Submittal Review Response

Project Name:	Hilo WWTP Rehabilitation and Replacement Project Phase 1 12330-001.0		
		Submittal No.:			
		Date:	[Publish Date]		
Client: <u>C</u>	County of I	Hawaiʻi	Carollo Project No.:	203975	
Contractor: N	lan, Inc.				
Submittal Name:	Camlock s	ubmittal			
Reviewed By: A	drienne F	ung			
Review is for general quantities, dimension comments. Refer to S	s, and det Section 01	ce with contract documents. No tails. No deviation or variation is	responsibility is assumed by Carollo for co approved unless specifically addressed in . The Contractor shall assume full responsi requirements.	these review	
COORDINATION WITH All C		No Exceptions	equilements.		
Approved		Make Corrections Noted - See	Comments		
		Make Corrections Noted - Cor	firm		
Not Approved	\boxtimes	Correct and Resubmit			
Not Approved		Rejected - See Remarks			
Filed for Record					
Receipt Acknowledge	ea 🗆	With Comments - Resubmit

PROJECT: HILO WWTP REHABILITATION AND REPLACEMENT PROJECT - PHASE 1

Adapter x 150# Flange

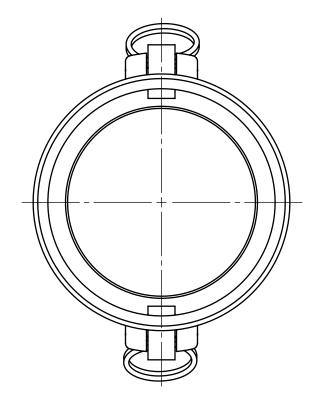
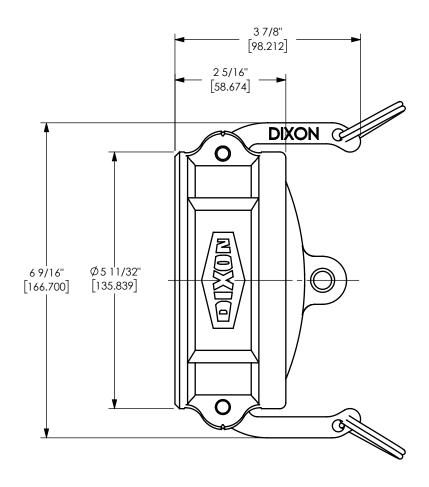
Contractor to identify which

Specification Section 01330.

product is being proposed, per

4" DIXON™ DUST CAP CAM AND GROOVE FITTING

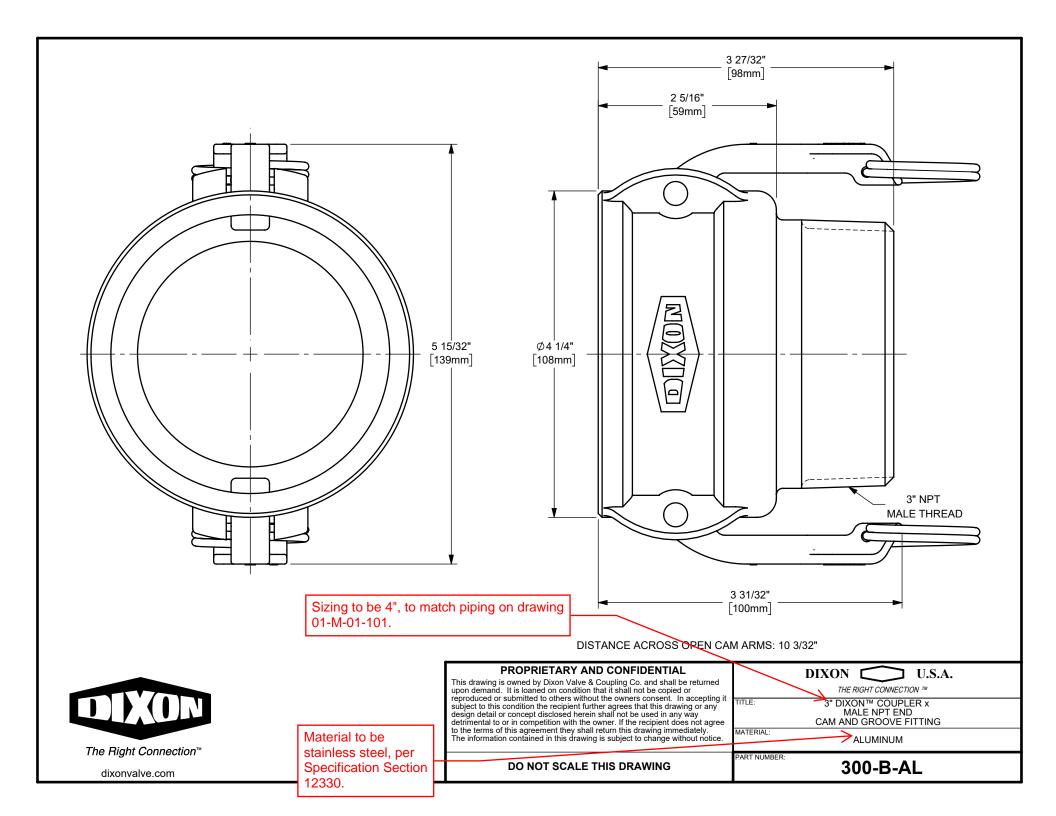
Contractor to identify which product is being proposed, per Specification Section 01330.
